Illinois Sports Facilities Authority
200 Level Kitchen Flooring Phase Two
ADDEDNUM NO 01
Rate Field - Chicago, IL
October 23, 2025

Addendum No 01 includes the following:

DEMO / REMOVAL PLAN

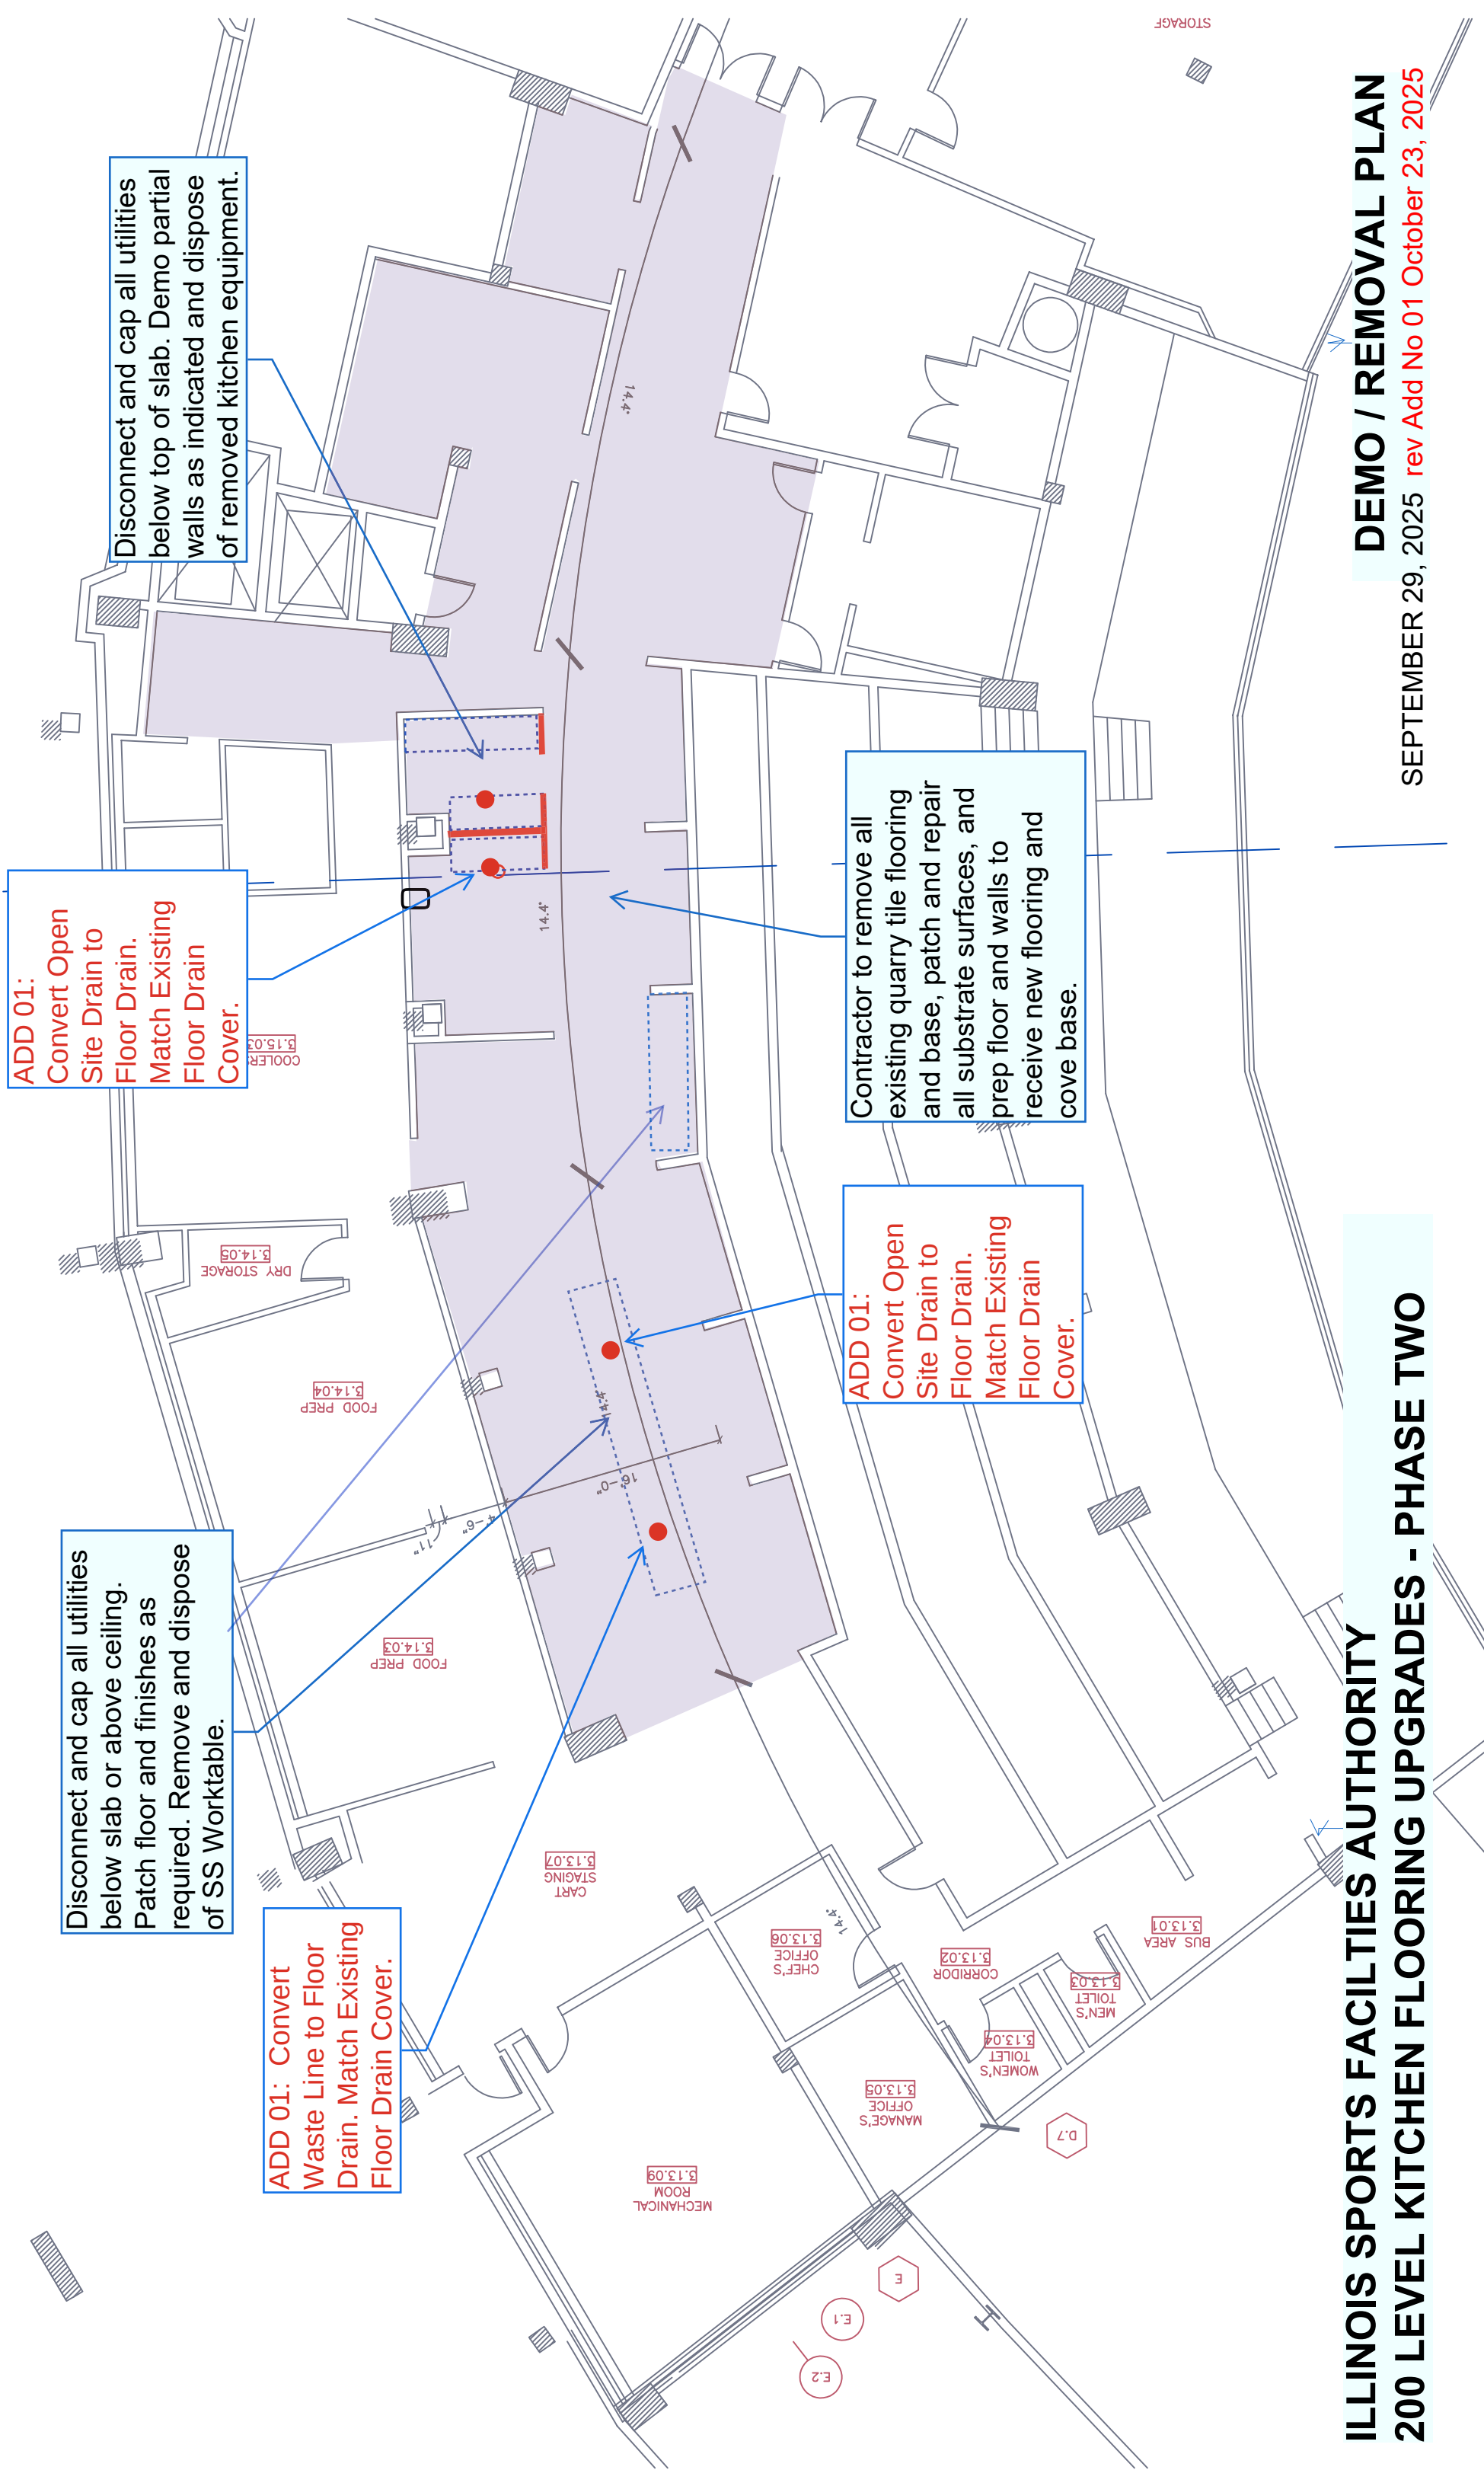
- Removal of plumbing and electrical components to include:
 - Plumbing:
 - Remove all plumbing piping to closest active line and cap.
 - Open site drain and waste line/drain under long table to be removed (see Demo/Removal Plan dated September 29, 2025, rev. for Addendum No 1 dated October 23, 2025) to be converted to floor drains. Match existing floor drain covers.

- All floor and open site drains to be coordinated with new finish flooring and reset as required.
 - Electrical:
 - Below slab conduit/pathway from electrical box in island table slab to source may remain. All wires to be removed.

- All electrical cable/wiring to be removed (in knee wall to be demoed) back to source or closest active junction box.
